**PLANNED UNIT DEVELOPMENT
& SUBDIVISION STAFF REPORT****Date: February 7, 2008****DEVELOPMENT NAME**

Congress Street Subdivision

Planned Unit Development Approval to allow shared
access and parking between two building sites, and Subdivision approval to create 1 lot.

SITE PLAN

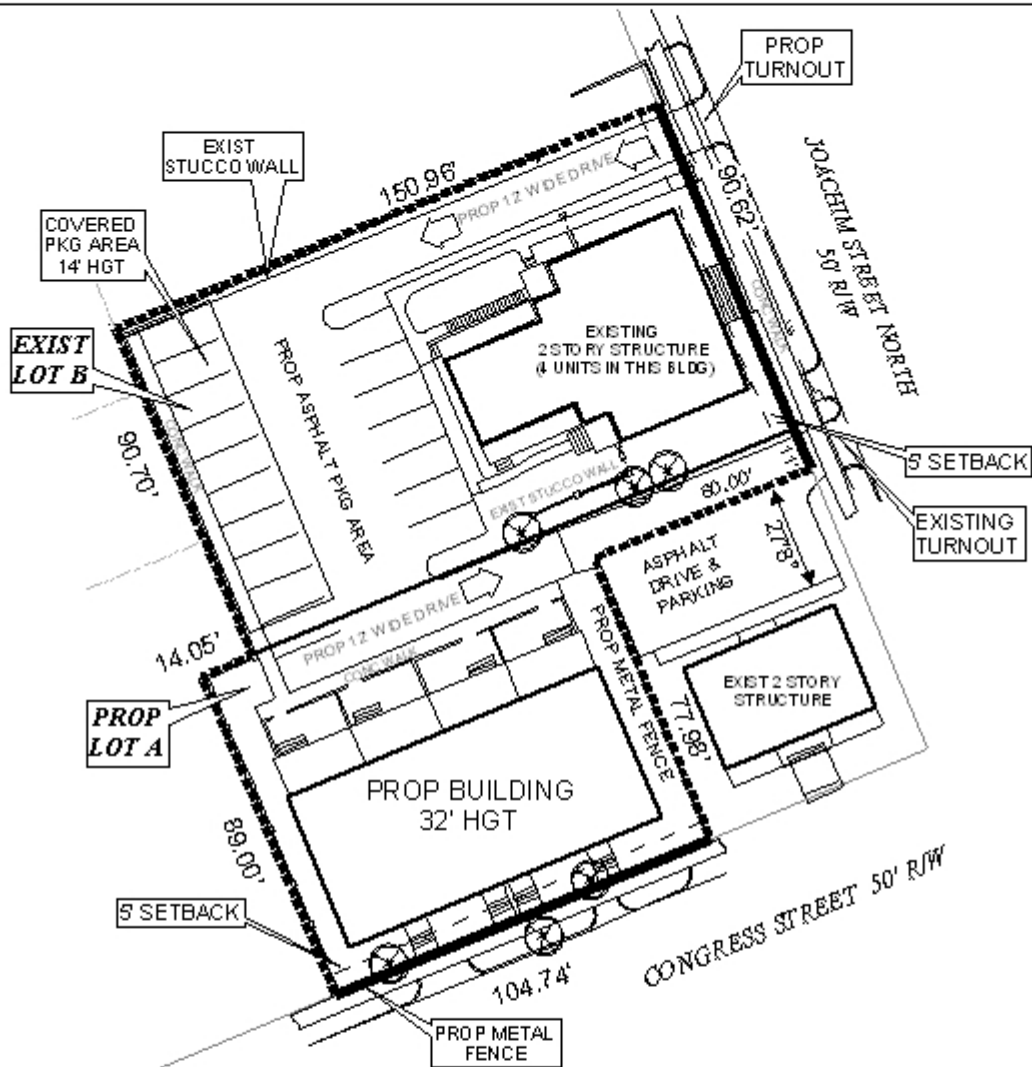
The proposed parking area will be accessed via a one-way entrance from North Joachim Street, and will exit via a separate one-way entrance onto North Joachim Street. It appears that the entry drive will be approximately 12-feet wide, however, it appears that the exit drive will fall below this dimension. It also appears that the exit drive will share access with an adjacent structure located at the corner of Joachim and Congress Streets: this adjacent site should also be made a part of the PUD application, or shared access between these sites should be eliminated.

As the applicant is proposing a PUD, the PUD common area requirements of 700 square feet per dwelling unit shall apply. No information has been provided regarding the total number of dwelling units nor the total area of the site devoted to common area or landscaping. The site plan should be revised to include this information.

The existing lot appears to have one existing curb-cut onto North Joachim Street which will not be used for the proposed development: the existing curb-cut should therefore be removed. The proposed lot appears to have two existing curb-cuts onto Congress Street, and one existing shared curb-cut onto Joachim Street: the Congress Street curb-cuts will not be utilized for the proposed development, thus they should be removed and the area landscaped.

No dumpster is depicted on the site plan. If a dumpster is proposed, it should be depicted on the site plan, or a statement should be provided indicating that no dumpster will be included as part of the development.

The 25-foot minimum building setback required by the Subdivision Regulations should be waived in favor of the 5-foot minimum building setback allowed by the R-B zoning district, per the Zoning Ordinance. The plat and PUD site plan should reflect the 5-foot minimum building setback line.

- 2) Revision of the site plan to identify the number of dwelling units in the existing building and the proposed building;
- 3) Revision of the site plan to provide landscape area information to depict compliance with the tree and landscaping requirements of the Zoning Ordinance, as well as the per-unit landscaping requirements of the PUD regulations, and potentially provision of a statement about the innovative nature of the development to explain why not all of the 60% of the 12% of the required landscaping can be placed within the frontage area (if this is the case), and explaining how it will be accommodated elsewhere within the development;

- 4) Revision of the site plan to depict elimination and landscaping of any curb-cuts determined unnecessary for the development;
- 5) Revision of the site plan to depict / calculate site coverage area for any portion of the site covered by a roofed structure;

- 6) Revision of the site plan to include a statement regarding the provision of a dumpster, or placement of a note on the site plan stating that dumpsters will not be provided as part of the development;

- 5) Depiction of the 5-foot minimum building setback line, as shown;
- 6) Compliance with Engineering Comments (*Denote entire area in AE flood zone with minimum finished floor elevation = 13.00 on plat. All storm water must tie subsurface to City of Mobile storm drain system including roof drains. It is the responsibility of the applicant to look up the site in the City of Mobile (COM) GIS system and verify if NWI wetlands are depicted on the site. If the COM GIS shows wetlands on the site, it is the responsibility of the applicant to confirm or deny the existence of wetlands on-site. If wetlands are present, they should be depicted on plans and/or plat, and no work/disturbance can be performed without a permit from the Corps of Engineers. Must comply with all storm water and flood control ordinances. Any work performed in the right of way will require a right of way permit.*);

- 7) Revision of the PUD site plan to reflect condition # 4 (showing tree compliance), and provision of two (2) revised PUD site plans to the Planning Section of Urban Development prior to the signing of the final plat;
